# Great Musgrave EDE/25

*Report for The HRE Group*

*Revision A, 9 May 2022*

Bill Harvey Associates Limited (BHA Ltd.) were asked by The HRE Group to review past inspection and assessment records, planning application, and other documents related to the in-filling of Great Musgrave bridge, and to comment on the suitability of in-filling as a treatment of masonry bridges.

Figure 4.2: Plan dimensions from 1998 assessment report.

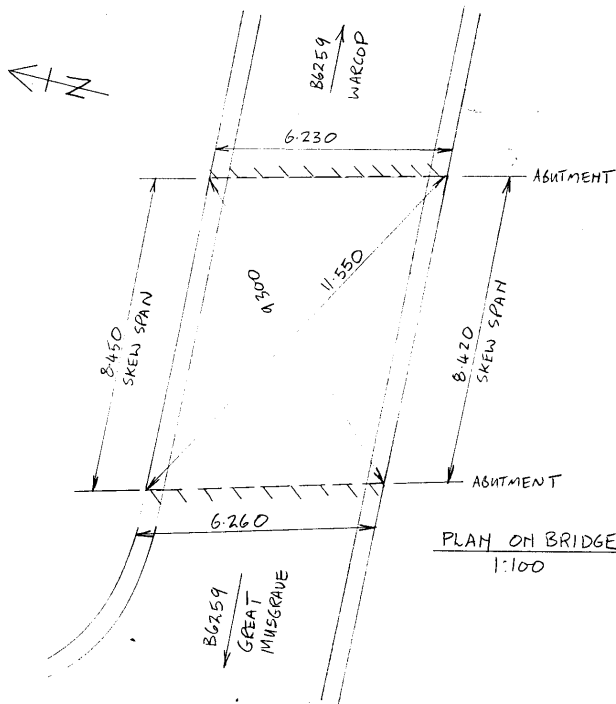
We can estimate the skew angle from the span, width and diagonal dims using the cosine rule (eqn 4.1, with terms as shown in figure 4.1). Depending on the triangle chosen, the skew comes out at 12.7° to 12.8°.

Thus the centres were 27 foot span and placed square to the abutments.

Figure 4.3: South elevation dimensions from 1998 assessment report.

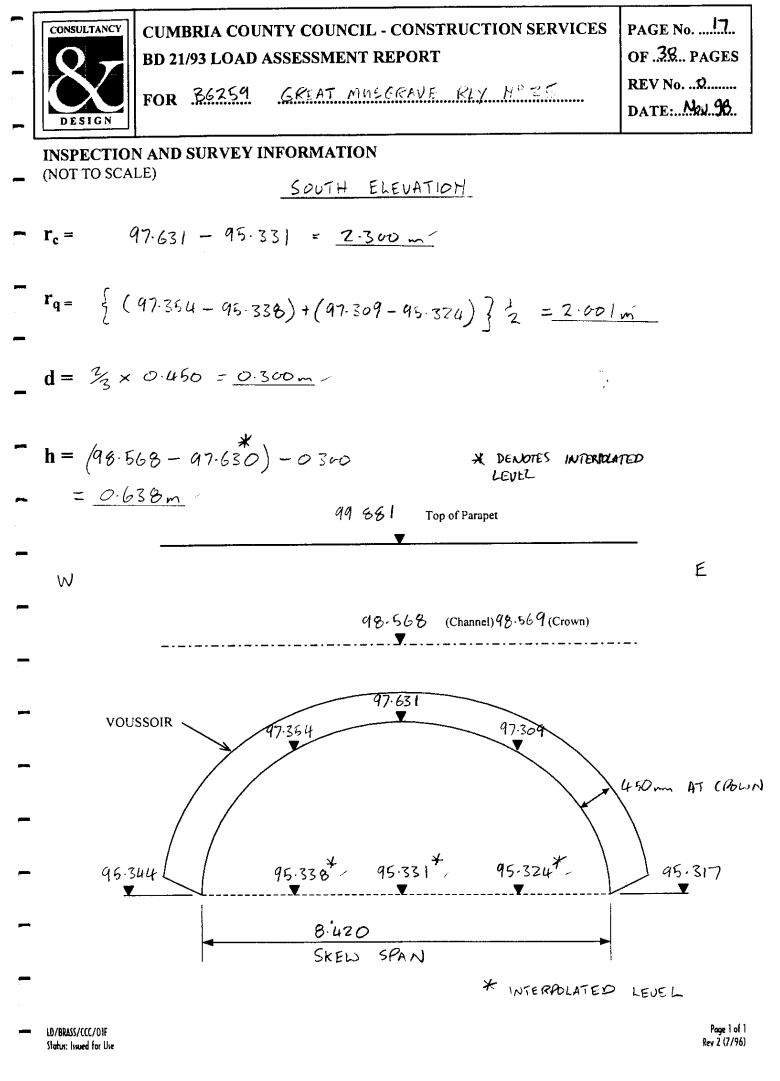
Figure 4.3 shows the south elevation dimensions. These are shown as levels, measured at the springings, quarter points, and crown.

We do not know how these levels were obtained. Measurements are reported to the nearest millimetre, which is unjustifiable whatever the method. The level difference at the springings of 30 mm is surprising and would warrant comment and checking. Quarter point measurements are particularly difficult, as they are very sensitive to position in the span.

So the shape is within measurement error of a true ellipse.

Figure 4.4: North elevation dimensions from 1998 assessment report.

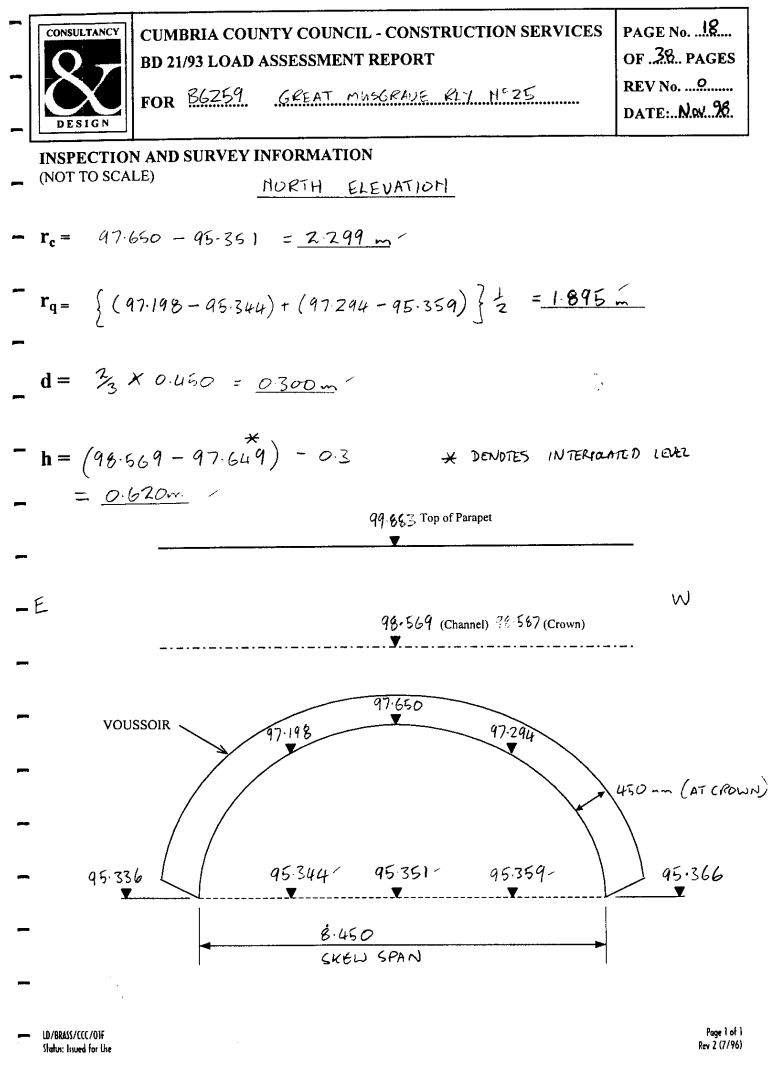
Looking now at the north elevation, dimensions in figure 4.4, things get less convincing. The 20 mm difference in level between the abutments is repeated here, but a drop of this scale across the span would show as distress in the spandrel wall masonry. A 20 mm level difference between elevations is also suggested, and

Rather than addressing the question of whether these tilts are real and, if they are, how they might have come about and what that means for the bridge, the 1998 assessment proceeds by taking them as given and interpolating between them.

These values for levels and rise show a range of deviations from likely truth. The bridge was undoubtedly level across both span and width at construction. Tilts of 20 mm in both directions would surely have visible effects.

Figure 5.1: A recent photograph showing elevation and soffit.

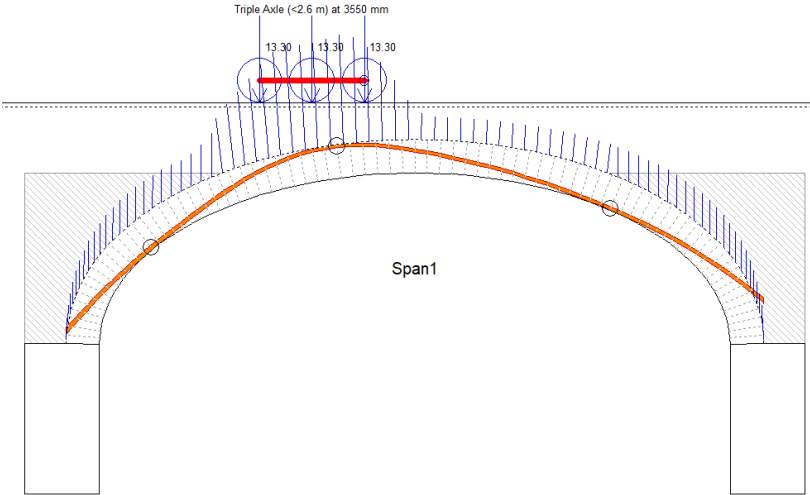
Figure 5.1 gives a view of the elevation and soffit. The water marks suggest backing at least to the sixth voussoir from the end but more likely the ninth, which would be more or less level with the arch crown intrados.

Figure 5.2: Worst case AWR load for Great Musgrave geometry, with backing to crown intrados level.

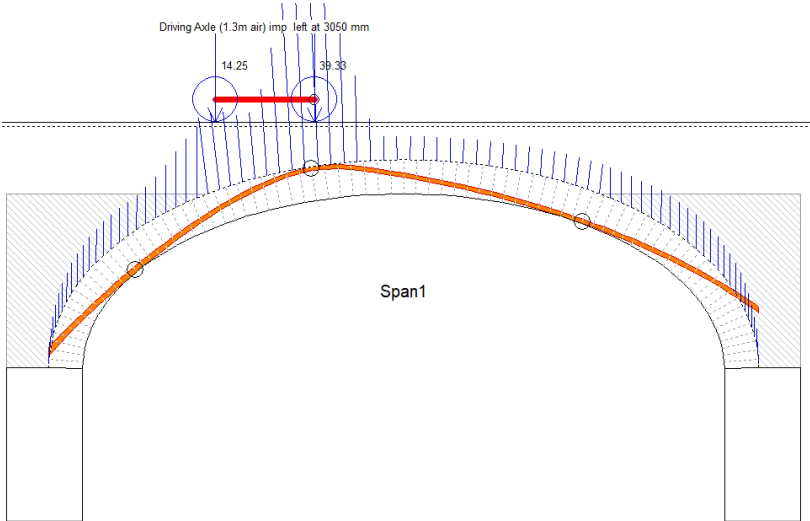
On that basis, the bridge would suffer no damage from any AWR vehicle. The worst case would be as shown in figure 5.2. For loads with impact, the worst case is shown in figure 5.3

Sensible application of either Modified MEXE or the Archie-M approach shows a capacity in excess of that required for 44 tonne vehicles.
